# Rozelle Laneways

[Redevelopment of the Tigers Leagues Club Site]

Council Letter and AEP Report Design Response

**20170127-AR-DA010**

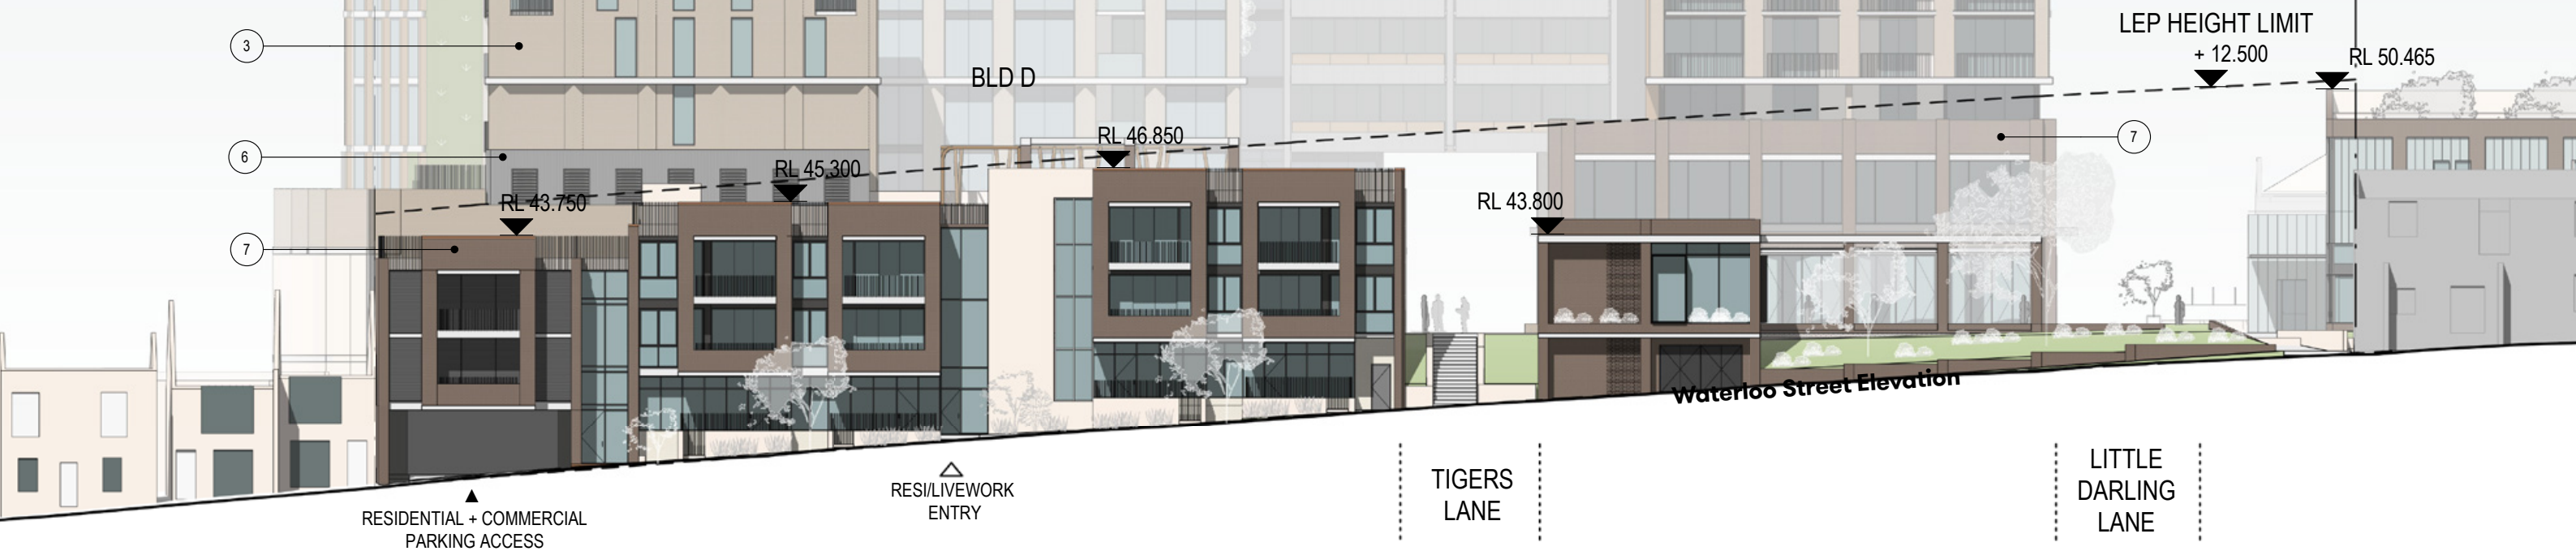
- c. **Recommendation 1:** The proposal needs to create a stronger, safer and more amenable pedestrian address for Building C in addition to that currently provided on Victoria Road. The additional alternate pedestrian access to Building C could be provided from Waterloo Street via the lift located in Building D (and through the communal open space above the podium), or alternatively an augmentation of the secondary address co-located with the lobby to Building B. The Panel would support a minor building height non-compliance associated with a potential lift overrun at Building D for the sole purpose of improving the sense of address for Building C.

As a result of this, the lower end of Victoria Road interface has been redesigned, which now allows for a larger glazed lobby to Building C; both fronting Victoria Road and a landscaped setback to the adjoining property. We recognise this Lobby remains separated from Buildings A and B lobbies by way of the loading driveway crossing. However, this is not dissimilar to many other developments of a commensurate scale. The lobby is now forward and aligned to the footpath, as a result of the deletion of the slip lane (now that Victoria Road is not providing car parking access).

Therefore, Building C lobby remains on Victoria Road but with an improved address and amenity.

- Clear and legible street address to Victoria Road with an enhanced lobby off the Victoria Road, with entrance doors approx. 12 m from the vehicle crossing. The lobby looks to a landscaped courtyard and will provide the formal address for mail, deliveries and the like.
- Secondary access off the ground floor plaza for convenience of the residents to connect directly to the precinct.

[June 21 Winter Solstice - Northwestern Site]

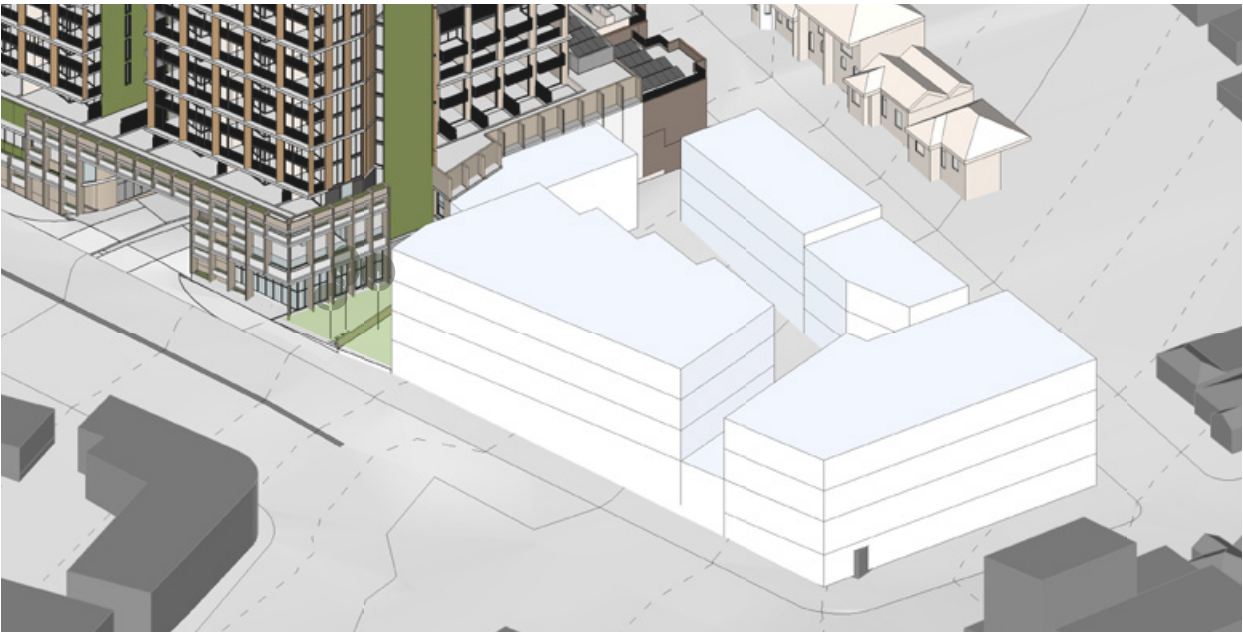
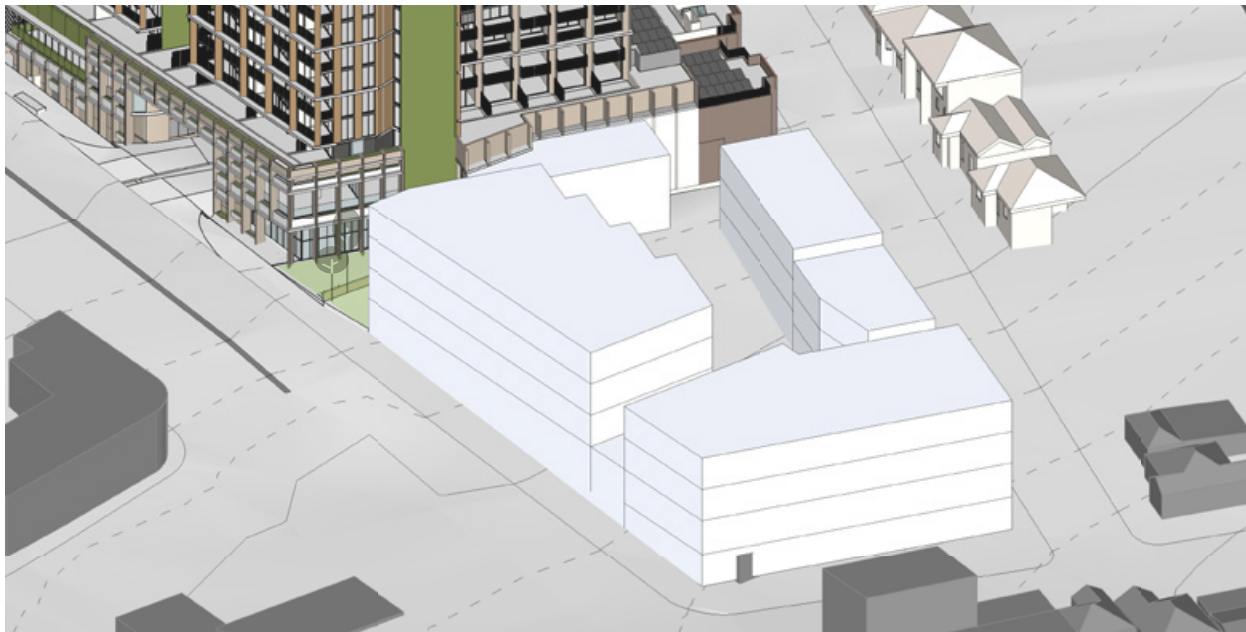
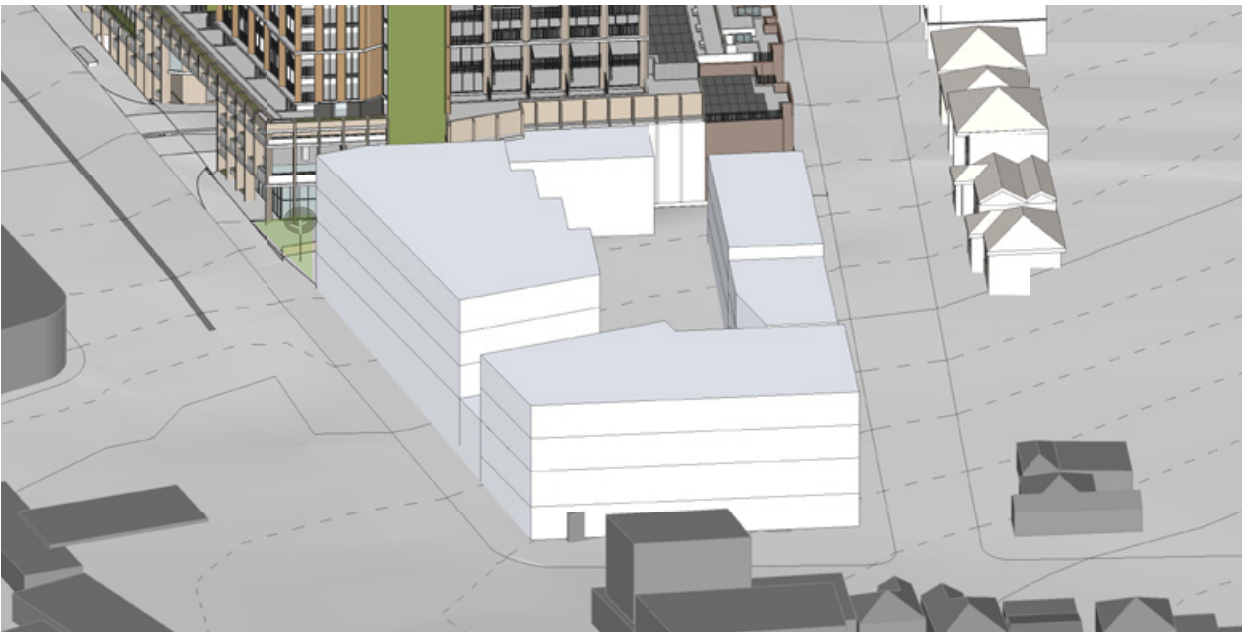
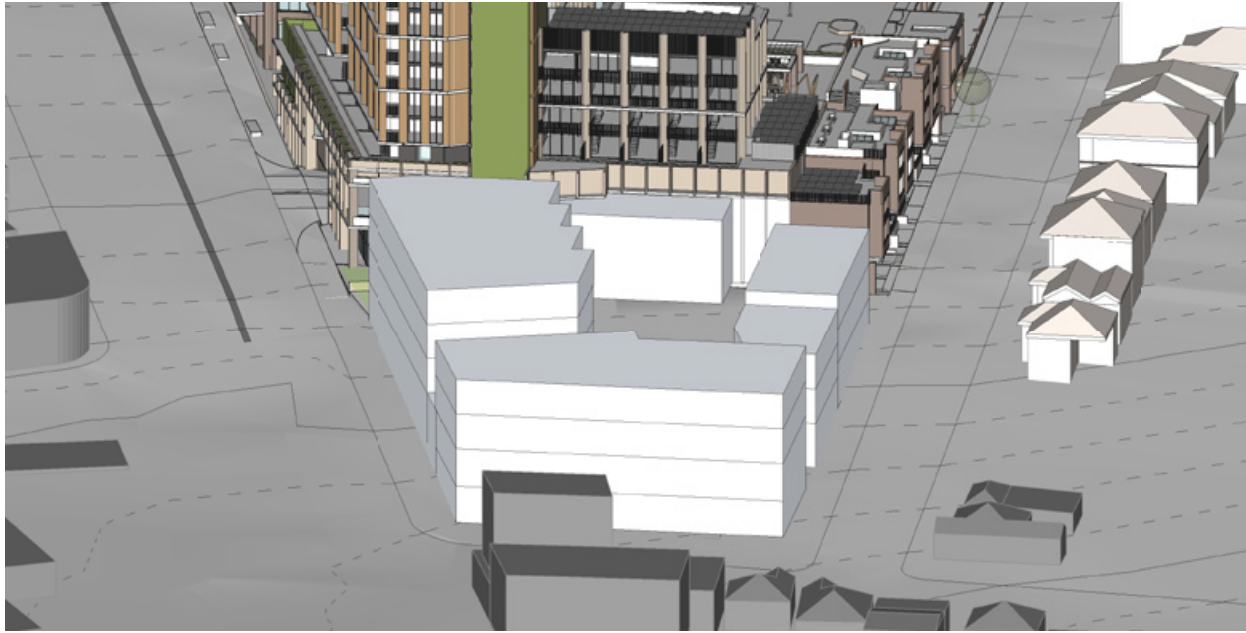
- b. **Recommendation 4:** The urban design study should include testing of future development scenarios for the neighbouring sites along the north western and south eastern boundaries. Testing should ensure that future development on the neighbouring properties is not compromised in terms of residential amenity, visual impact and solar access. Similarly, these tests should demonstrate that the amenity enjoyed by dwellings within the subject site can be maintained in scenarios where the neighbouring properties are redeveloped.

Scott Carver has prepared an indicative scheme to the adjoining properties, stretching between the subject site of this DA and Moodie Street. In effect this will rely on the consolidation of numerous parcels of land.

- Adopting the current LEP Planning Controls, noting the site specific controls of the subject DA are a consequence of the retention of the Club.
- The key planning control relates to an FSR of 1.5: 1 or approximately 5430m2 of development.
- The scheme provides retail on Victoria Road, turning into Moodie Street; with residential above.
- Low scale residential is provided along Waterloo Street.
- The result is a development of 4 levels that can provide a built form that abuts the north western bounding wall of the subject site. This bounding wall is the external boundary wall to the Club
- In the indicative scheme we have proposed a communal facility for the residents is provided abutting this boundary wall, which in turn reduced the perceived scale of the wall.

**Northern Elevation**

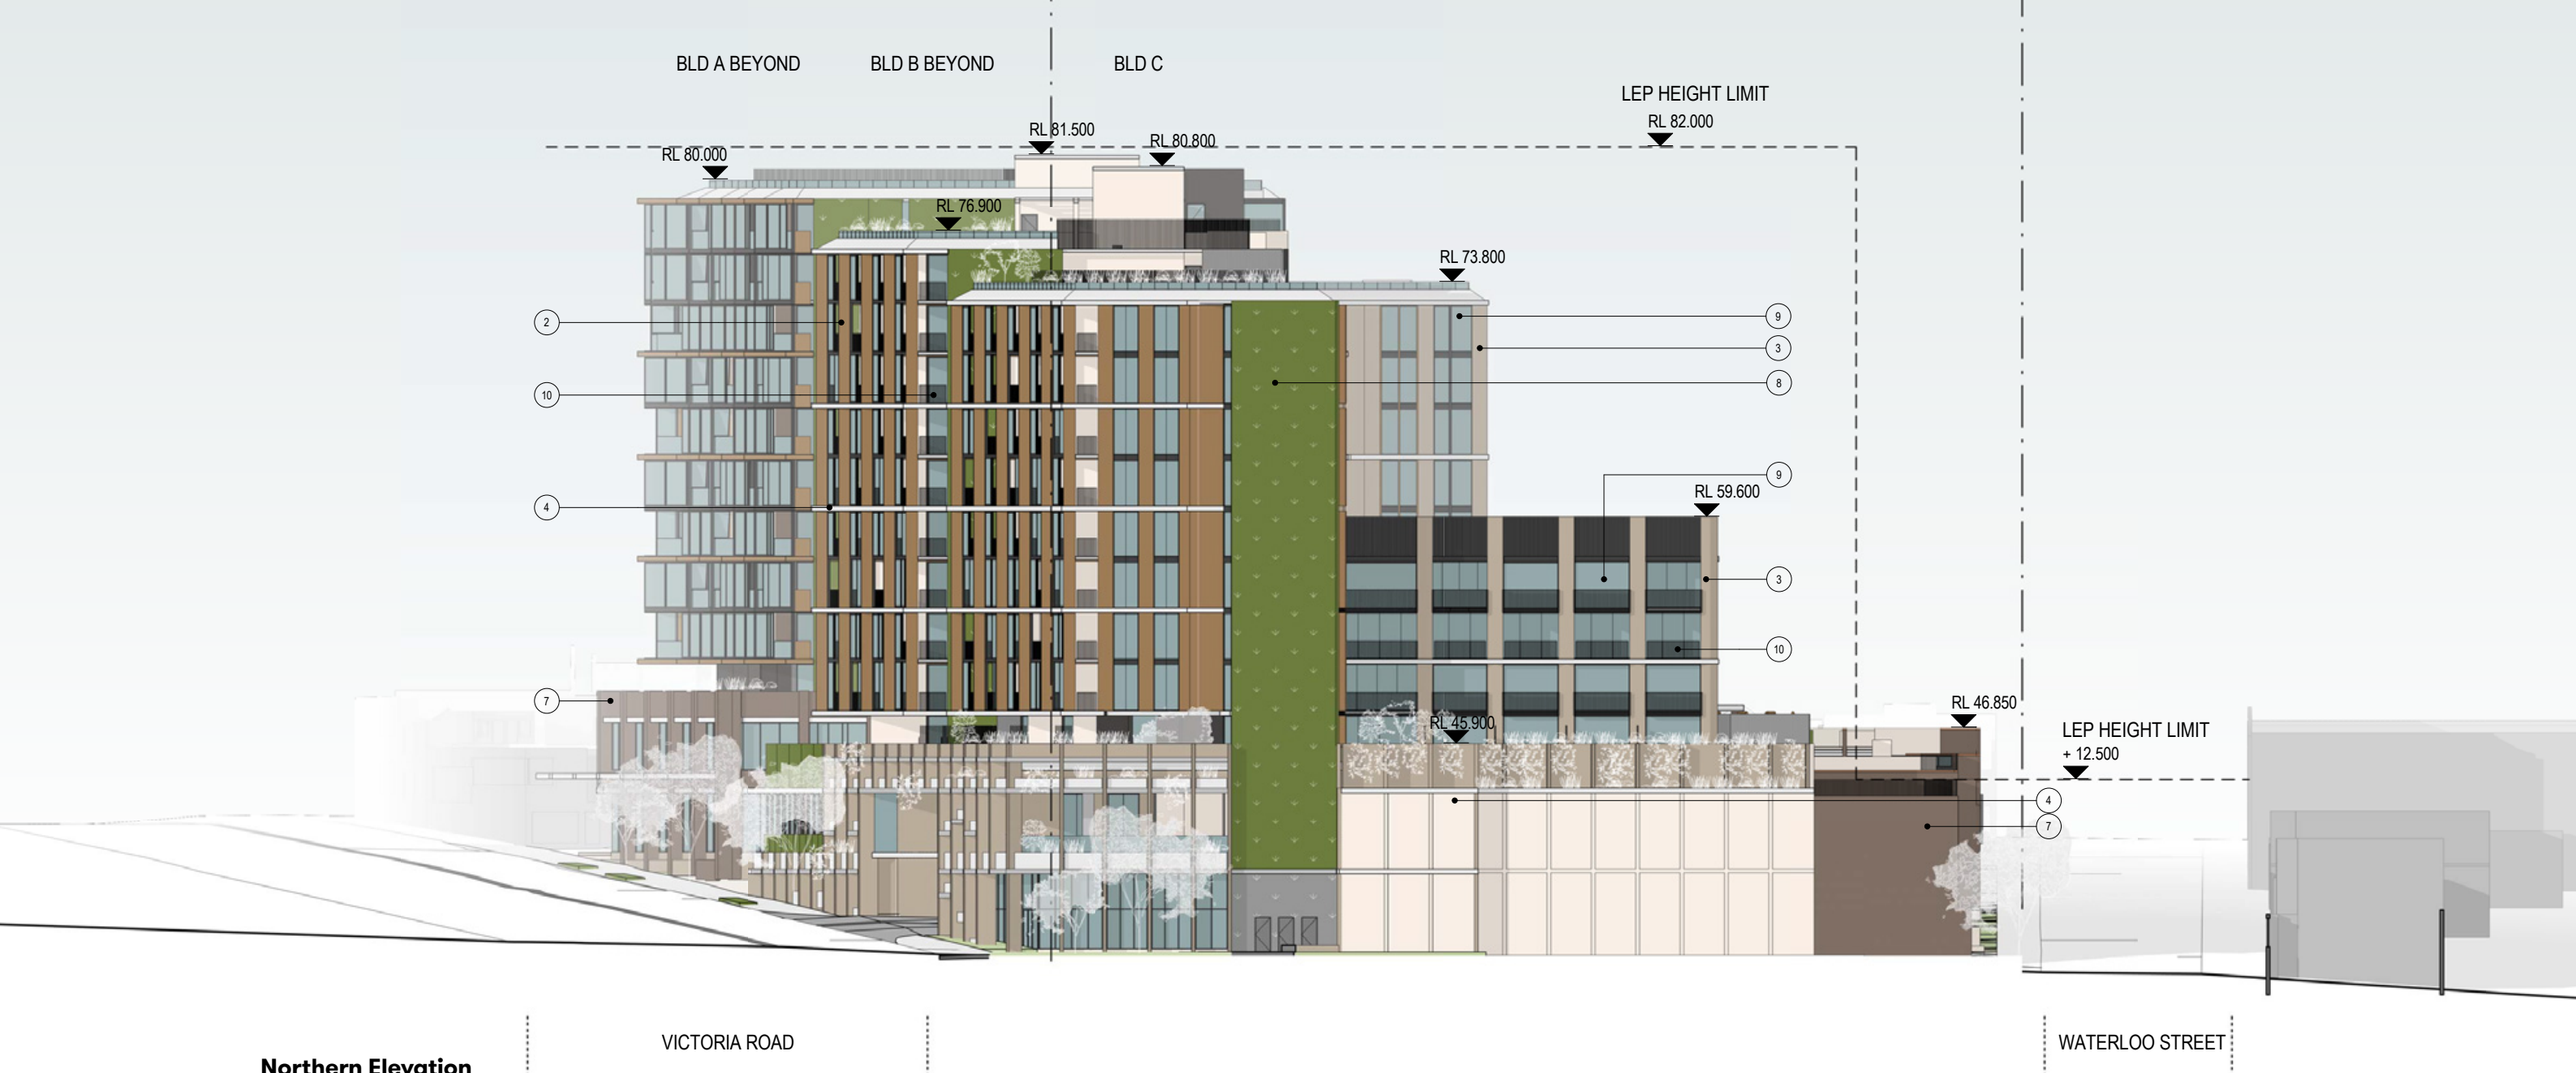
- c. The building base creates an approximately 15m high blank wall along the north eastern site boundary, which will create visual amenity impact on the neighbouring properties in the existing development scenario. The Panel recommends the incorporation of a range of mitigation strategies to lessen the impact of this interface.

Notwithstanding that, the wall along the boundary to the adjoining property has been reduced in height. Whilst the comments from AEP note the bounding wall as being some 15m high, we note that the boundary wall varied from 9.2m high at the western end (Waterloo Street) and 12.5m at the corner of the Club.

- Sets the podium in on the north west portion, adjoining Victoria Road. This is the new setback zone adjoining the Building C lobby.
- A result this allows the club brick façade to extend around the corner and for the green wall from Building C to drop down into this setback,

- The wall height bounding the Club has then been reduced by setting down the façade edge, and reintroducing the brick grid from the club façade. Landscaping has also been introduced above this edge in front of the terrace homes above (This provides a landscape zone that can provide a privacy screen to the terrace homes and in turn break down the scale of the bounding wall.
- Below the reintroduced brick grid the lower 2 levels is an articulated precast wall that aligns with the brick grid above.
